# SYNERGETICS

23 February 2024

**RE: NASF Guideline B review of proposed new awning at 125 Nancy Ellis Leebold Dr, Bankstown Airport**

**Figure 2 - Detailed plan view of the proposed awning (marked in blue). Image reproduced from (SBA Architects, 2024) with added markings to highlight the awning.**

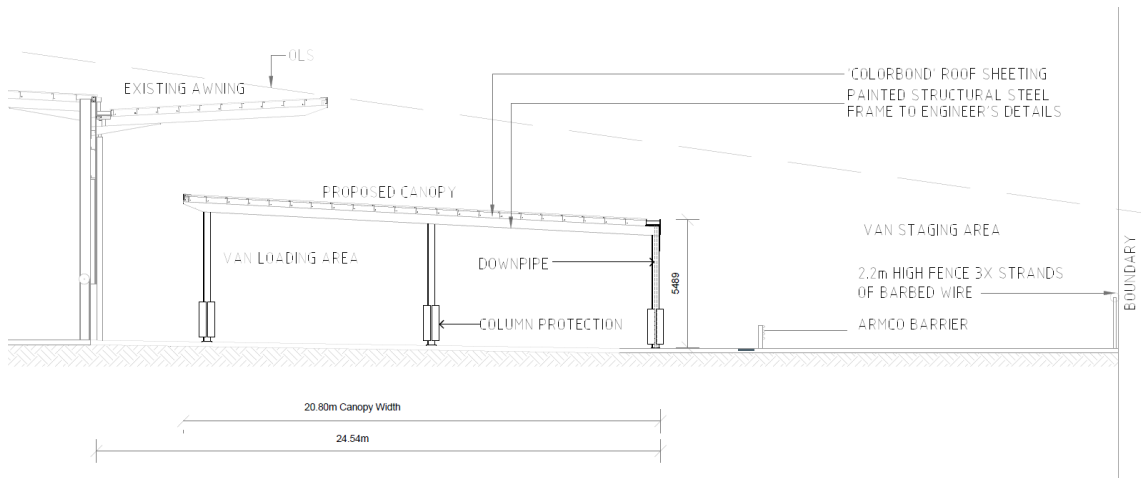
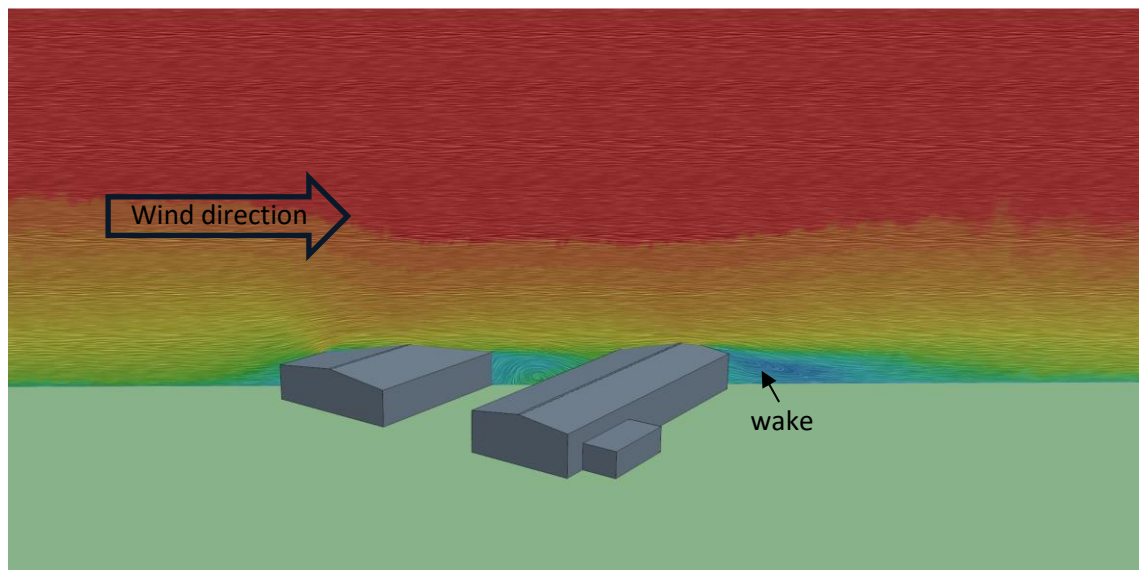
The existing building's ridge is approximately 12 m high<sup>1</sup>, with eaves approximately 10.5 m high. It features an existing 10.5 m high, 9.5 m wide, 93 m long canopy. The proposed awning, marked in Figure 2 and Figure 3, is 6.4 m high, 94 m long and 20.8 m wide. It sits directly between the building and runways, partially beneath the existing canopy.

The '>1:35 height to distance area' criterion, referred to in (DIRD, 2018) Paragraphs 51, 52 and 53, was assessed by calculating the ratio of building height to the perpendicular distance to each runway, with building height referenced to the local ground level.<sup>6</sup> As summarised in Table 2, Runway 11L/29R does not satisfy the '>1:35 height to distance ratio', and hence requires further assessment.

The proposed awning has the potential to generate windshear and turbulence. However, for wind directions of relevance to aircraft taking off and landing at Bankstown Airport, the proposed canopy extension will lie within the wake (e.g., Figure 4) of the existing building and will therefore not materially affect the wind shear and turbulence experienced by aircraft using the subject runways.

Windshear and turbulence levels experienced by aircraft using Bankstown Airport's runways are not expected to be materially affected by the proposed awning.
